FED. ROAD DIST. NO.	STATE	FED. AID PROJ. NO.	FISCAL YEAR	SHEET NO.	TOTAL SHEETS
HAWAII	HAW.	BR-STP-056-1(35)	2000	C.O. 17	70

WAIKAEA BRIDGE WIDENING

KUHIO HIGHWAY-WAIKAEA BRIDGE WIDENING
Fed. Aid Proj. No. BR-STP-056-1(35)

SECTION B
Scale: 3/8"=1'-0"

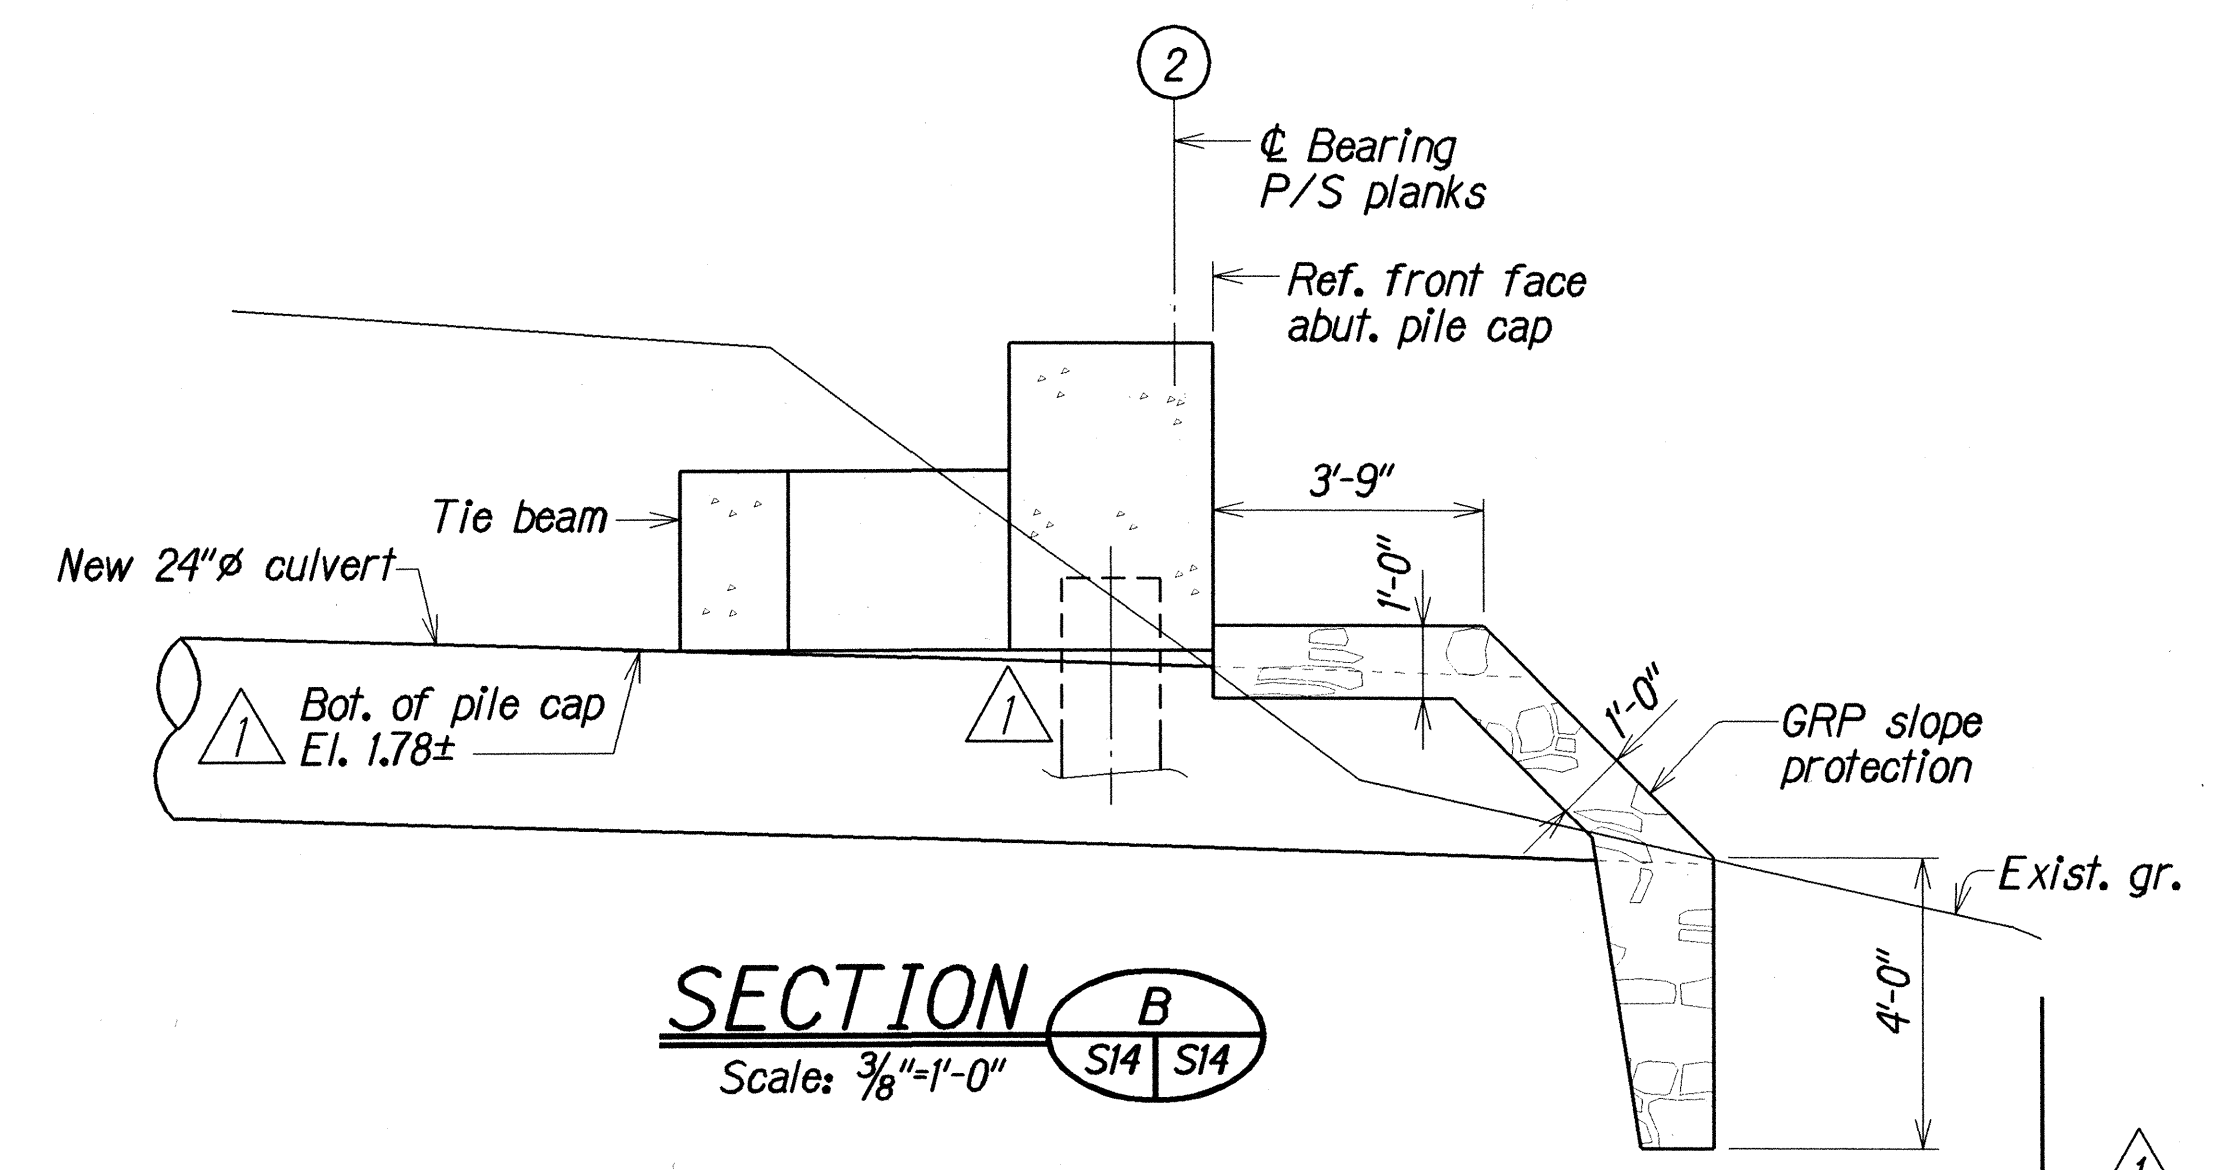
1
6/6/01
Bot. of abut. pile cap elevation changed. Piles, bridge, wingwall, abut. pile cap & 24"Ø culvert lowered to accommodate changes. GRP removed behind front face of abut. pile cap. Labels moved and changed for clarity. Note #1 and dimension added. Slope matched with exist. swale.

TYPICAL ABUTMENT SECTION
Scale: 3/4" = 1'-0"

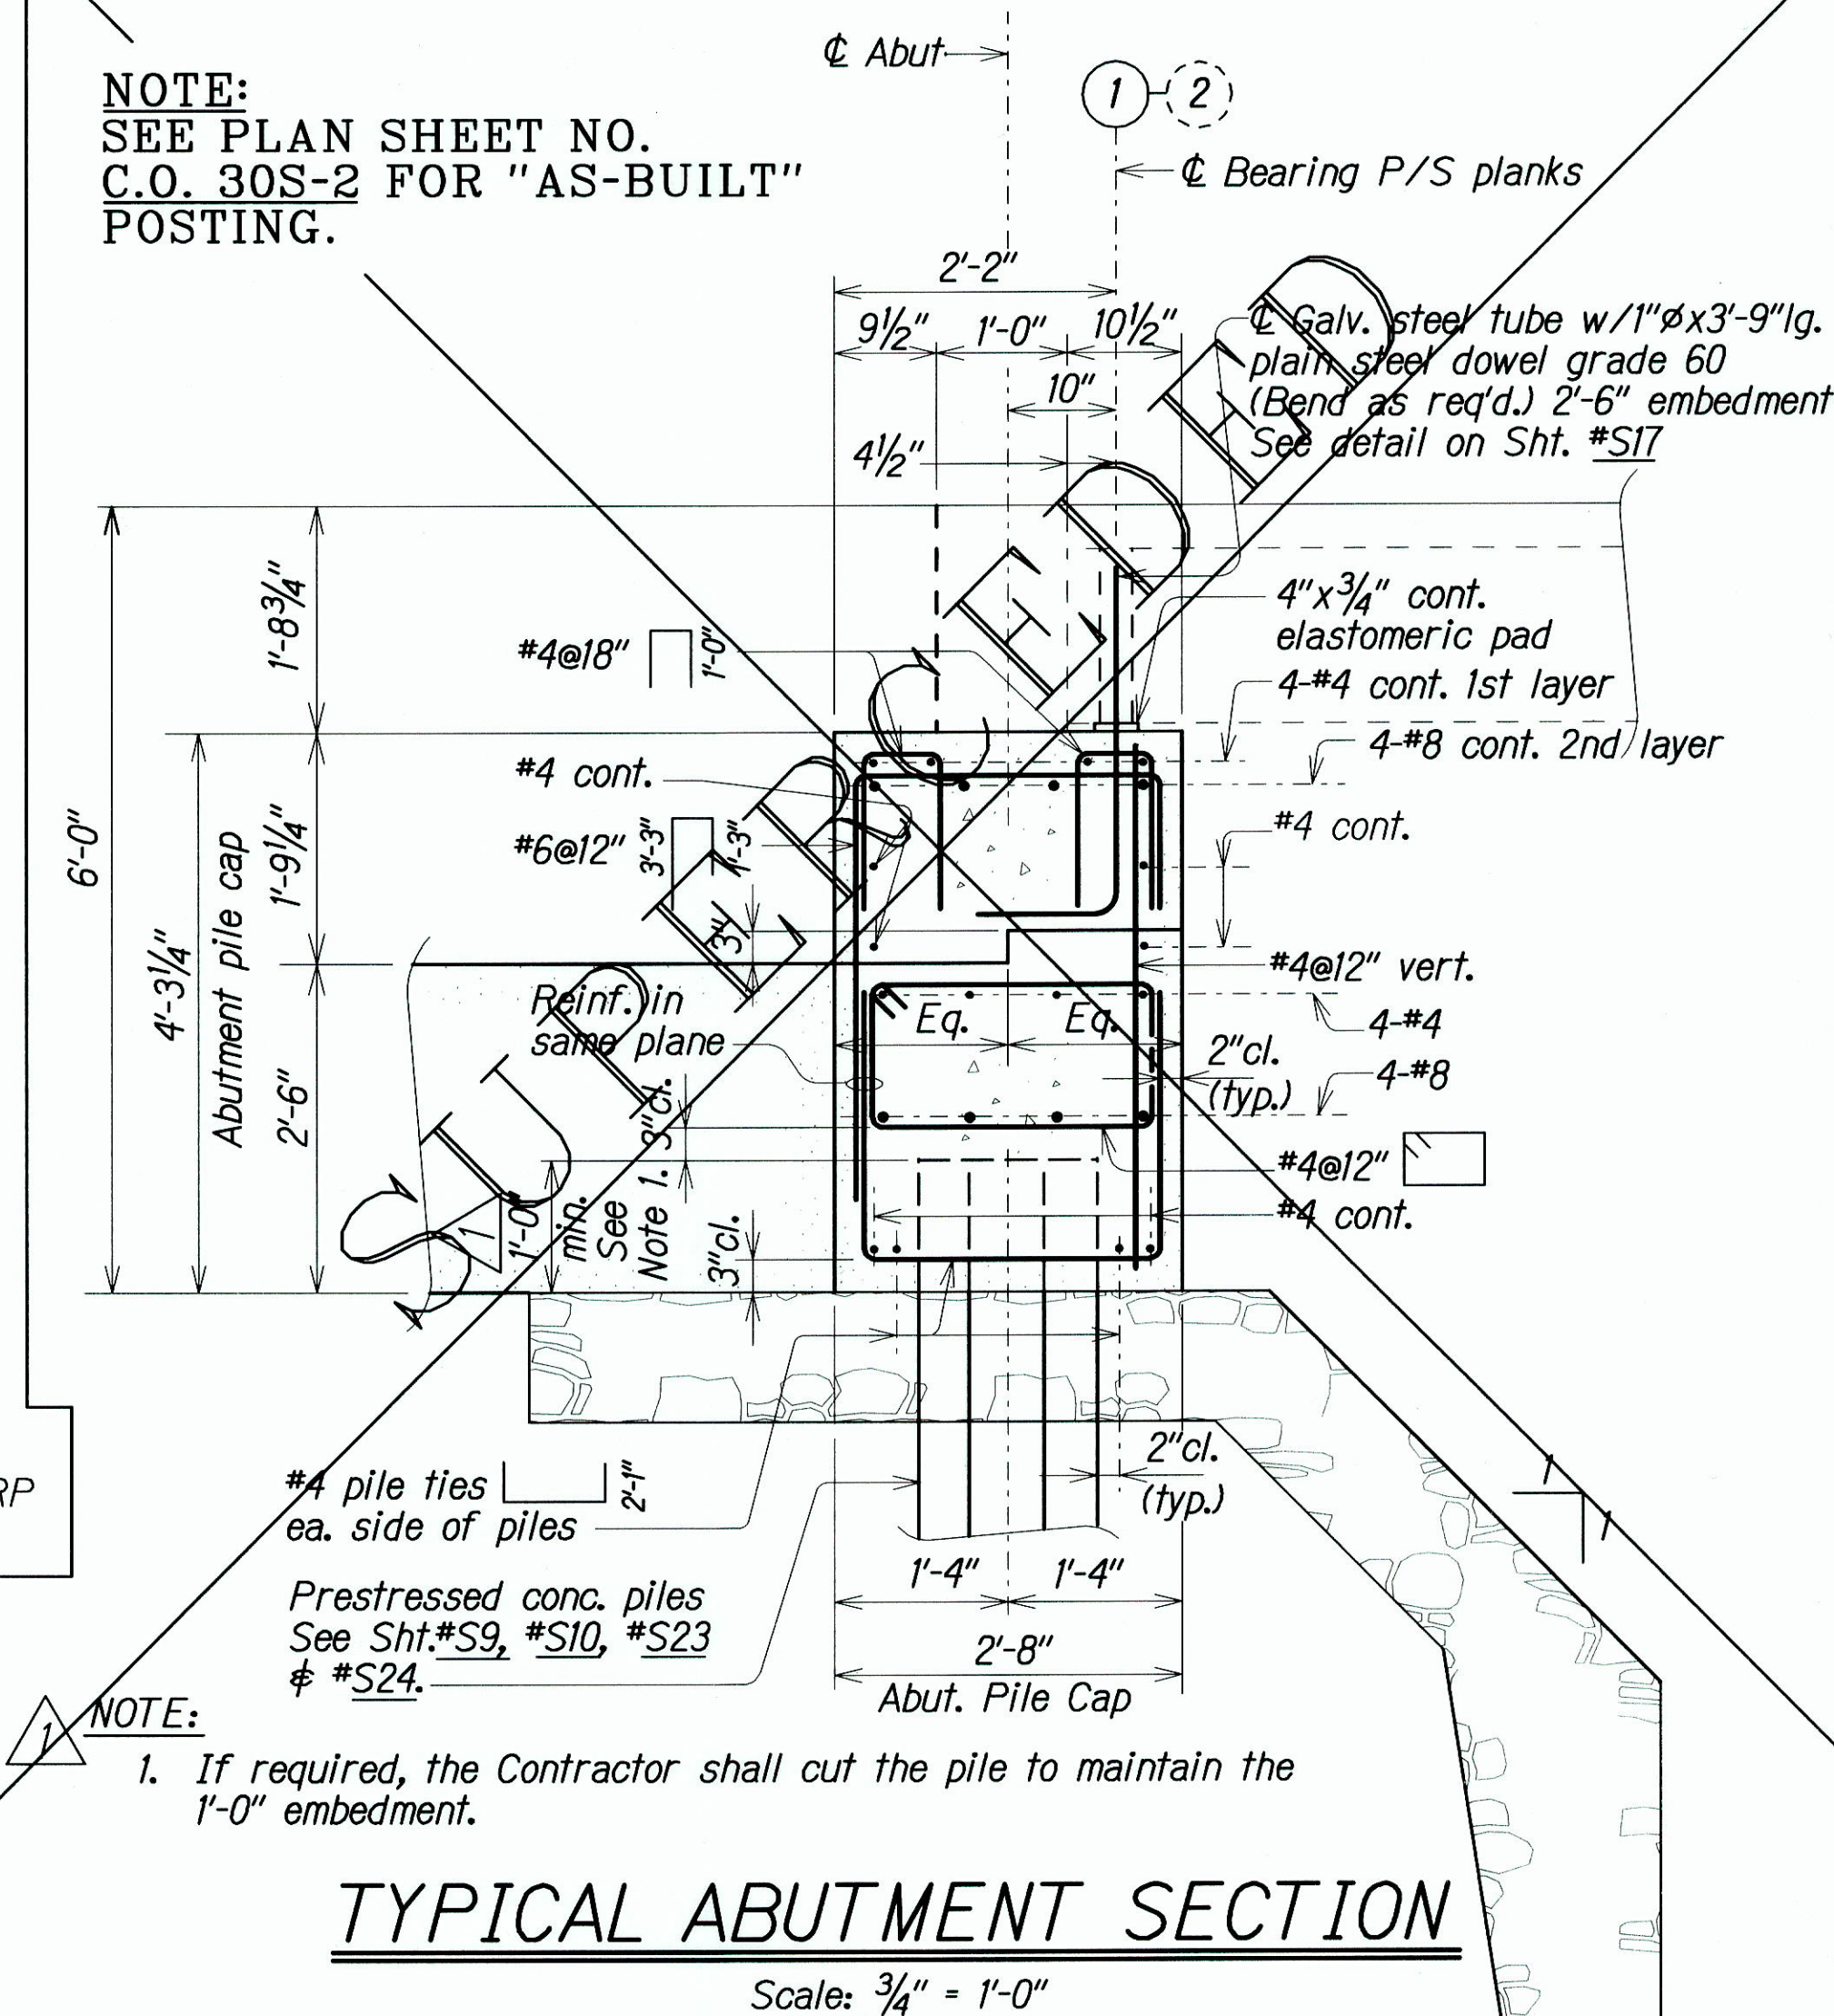
Added note to Typical Abutment Sect.
Moved dimension, dimension line & added to label for clarity.
